The Norfolk County Council (Norwich Northern Distributor Road (A1067 to A47(T))) Order

Habitat Regulations Assessment Addendum

PINS Reference Number: TR010015

Document Reference: NCC/EX/83

Figure 3.1: Process to assess likely significance of effect of sediment ingress for each road

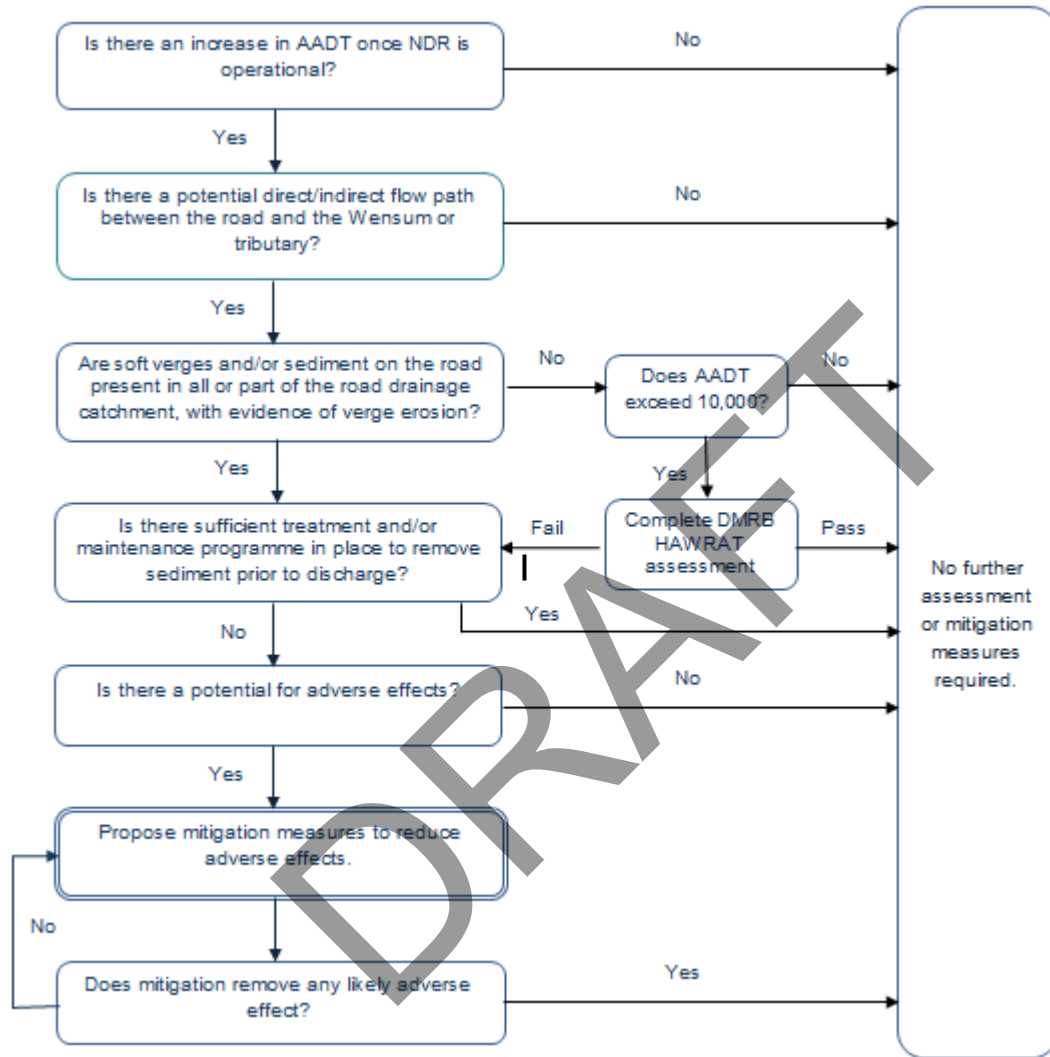
In our view this does not represent a sufficiently robust mitigation strategy. In figure 3.1 of the HRA addendum a flow chart is presented to show steps in the assessment of likely significance of silt inputs from road crossings. The proposed mitigation measures are not robust enough to remove any adverse effects, and therefore it cannot be concluded that no further assessment or mitigation measures are required.

Figure 3.1 (p14) outlines the process for assessing the likely significance of silt ingress at each road. Given that at Attlebridge there are soft verges on at least 50% of the road catchment draining to the river (see Drawing MMD-233906-DT-1005 in Appendix B), we do not agree that this road crossing should drop out at the third box down in Figure 3.1. Rather, the assessment should continue to a consideration of whether there is sufficient treatment and/or a maintenance programme in place to ensure that sediment is removed prior to discharge.

Figure B.2: Drainage plan and site photographs – The Street and A1067 at Attlebridge

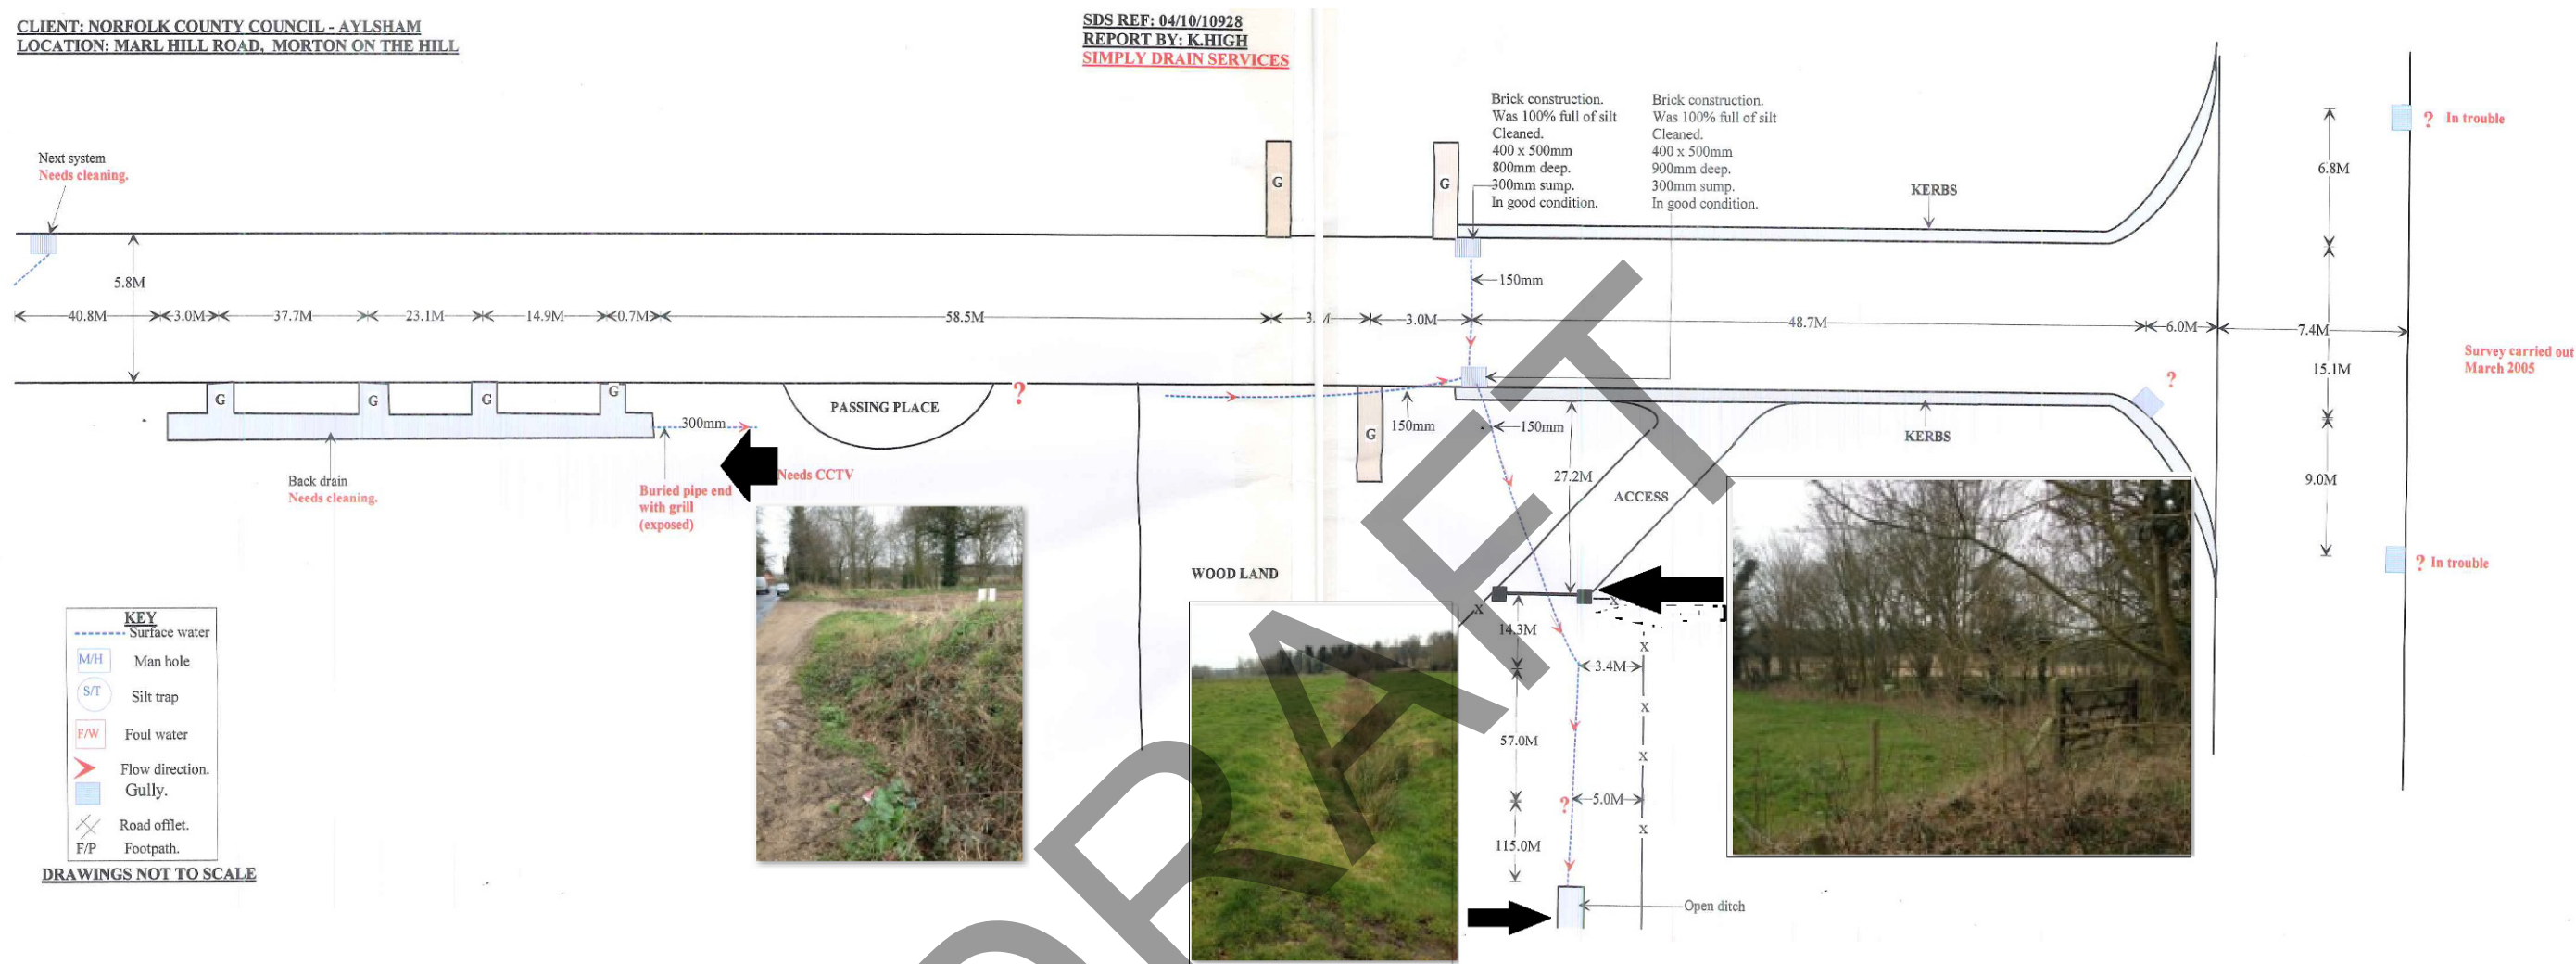
Measures might include the provision of new attenuation ponds/silt traps on nearby land. At Attlebridge, for example, there may be opportunities to modify the open dyke connected to the tributary stream (see Appendix B Figure B.2 for location), so that it is more efficient at trapping silt before it enters the Wensum. This might mitigate for the impacts of silt ingress from the north side of the road, although it would not address input from the slipway on the south side. At Lenwade, there may be opportunities for silt traps on land north of the A1067, subject of course to landowner agreement. Such options have the potential to provide betterment to the SAC. This is in contrast to the proposed actions which simply adopt best practice to manage the existing arrangement.
